# FOUNDATION INVESTIGATION REPORT

Ramp Structure 427 S - 407 E

Over Steeles Avenue

W.P. 88-78-23 Site: 37-80-1116

RAMP 427 S - 407 E  
OVER STEELES AVE (BRIDGE 13)  
BORE HOLE LOCATIONS & SOIL STRATA

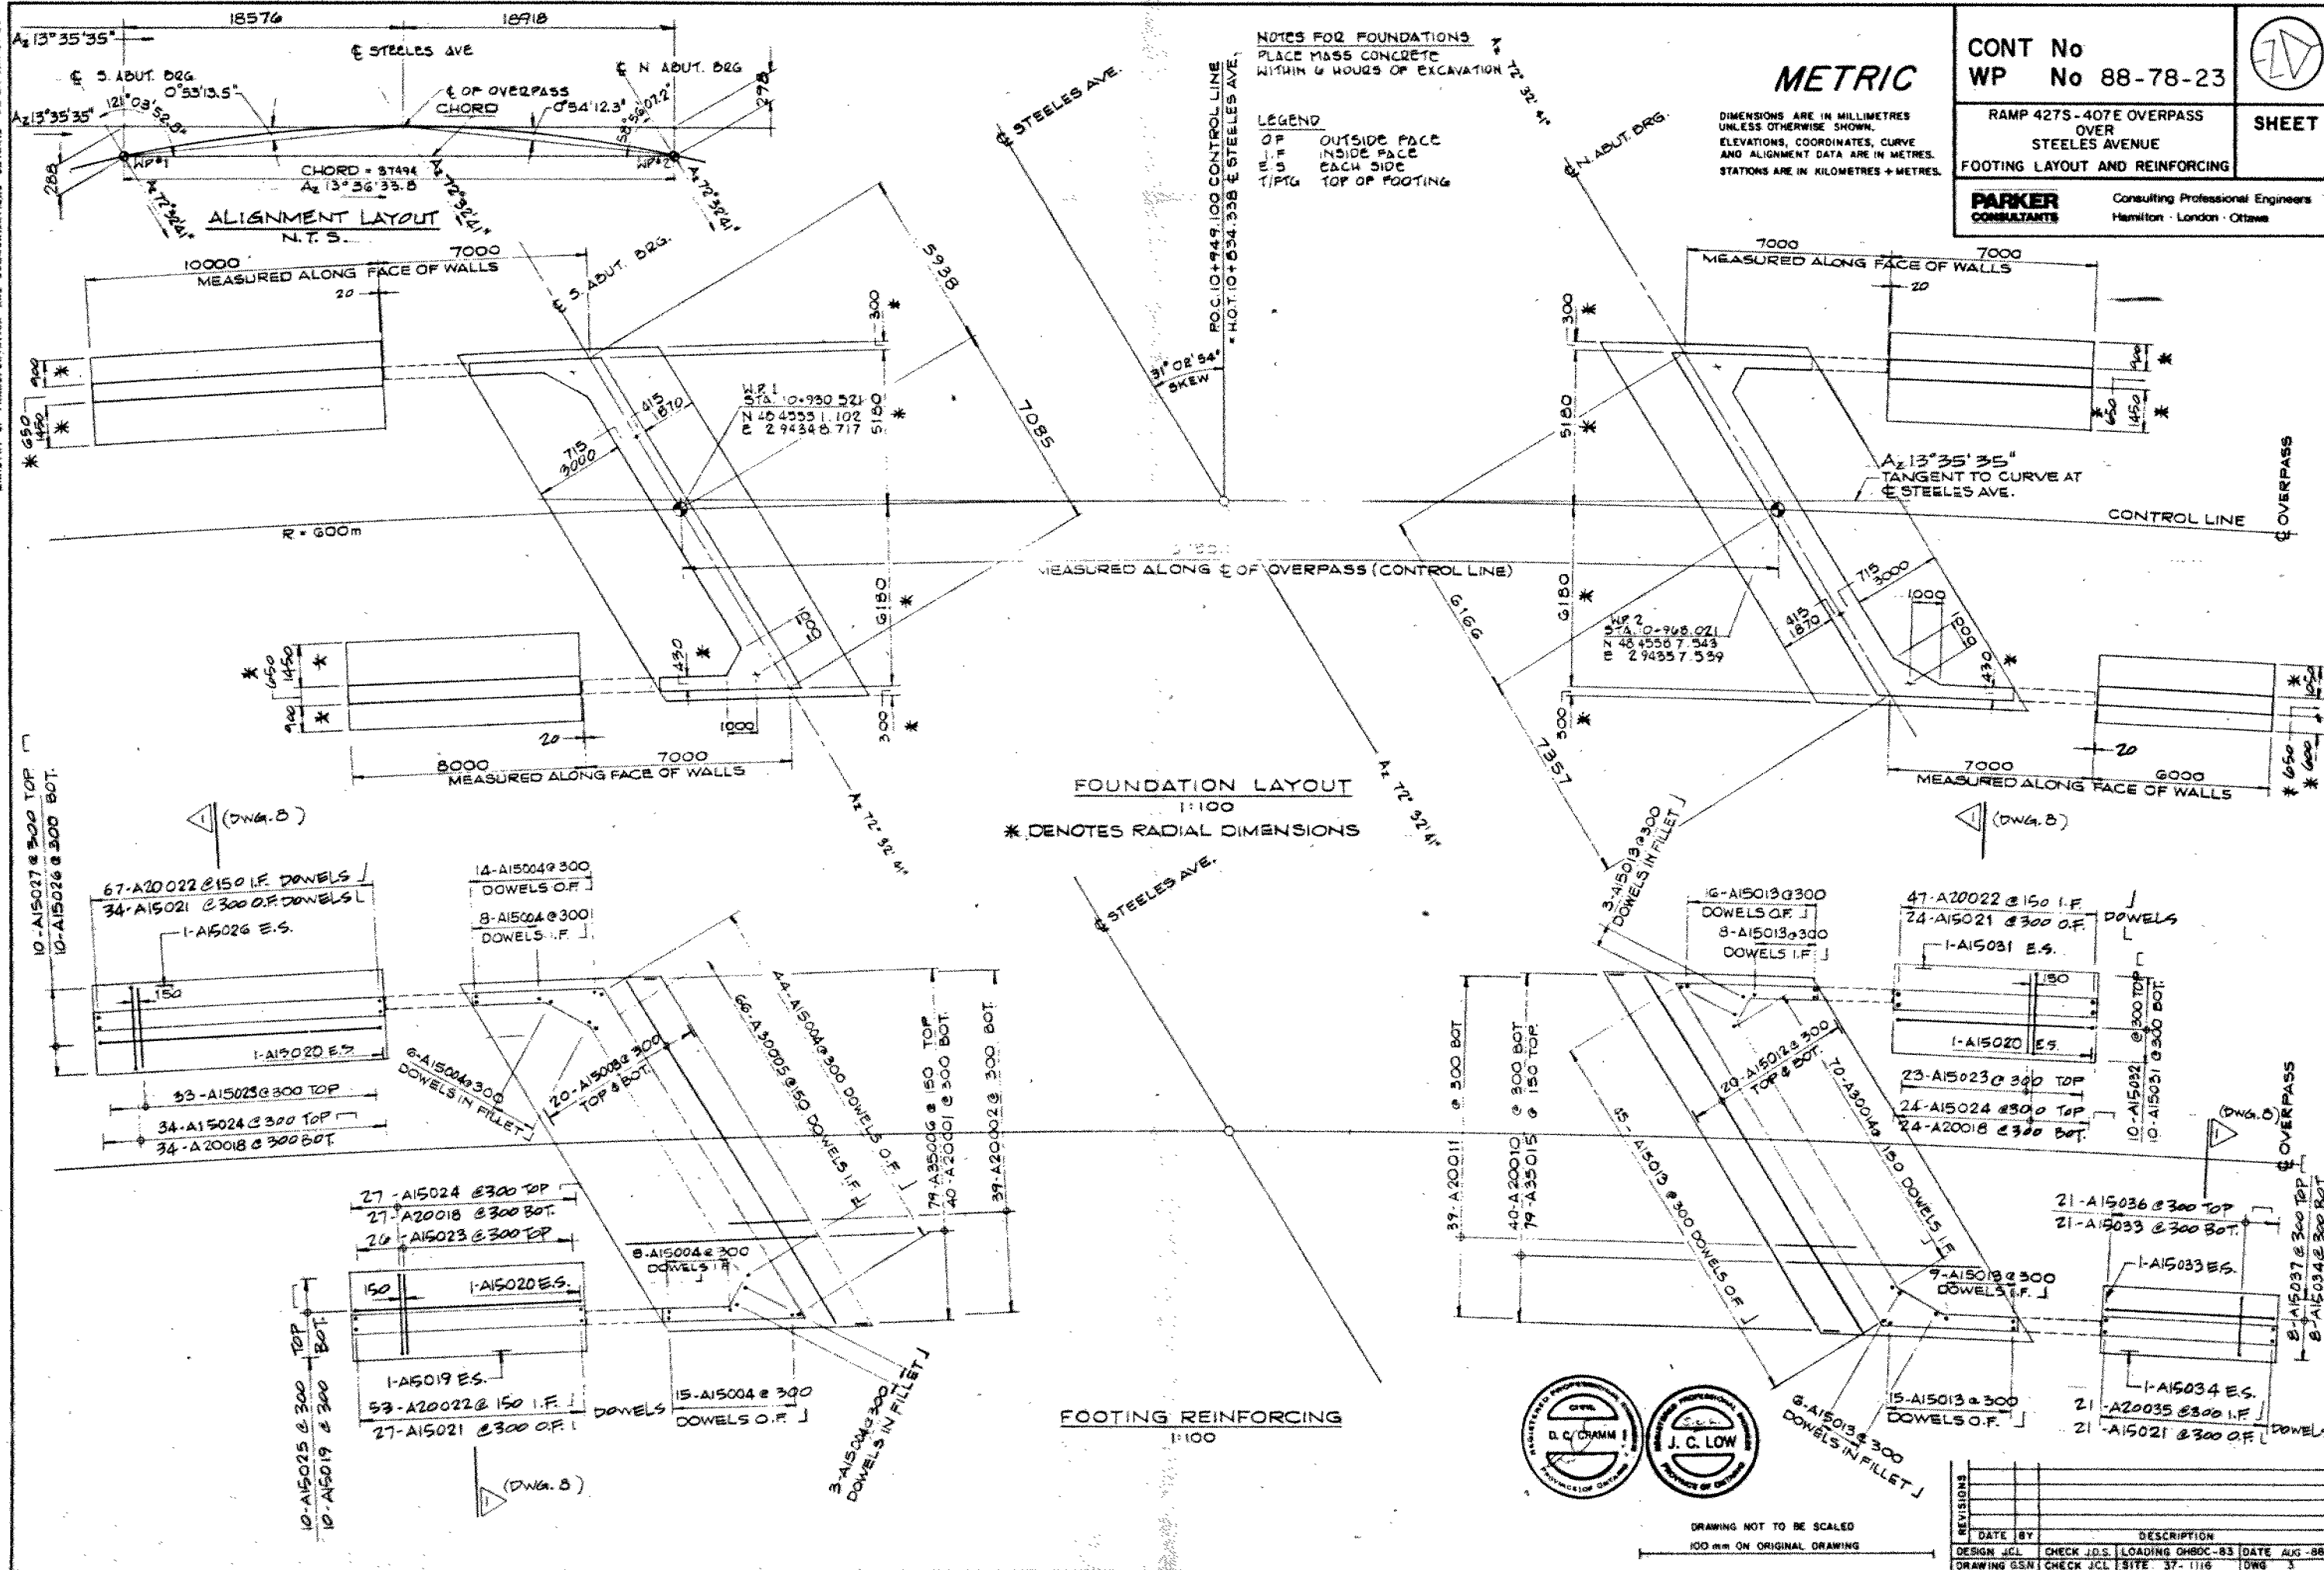
The boundaries between the various soil types, insitu and laboratory test results, as well as stabilized ground water levels, are shown on the attached Record of Borehole Sheets. The locations and elevations of the borings, along with a profile showing a simplified stratigraphical summary are shown on Drawing No. 887823-A.
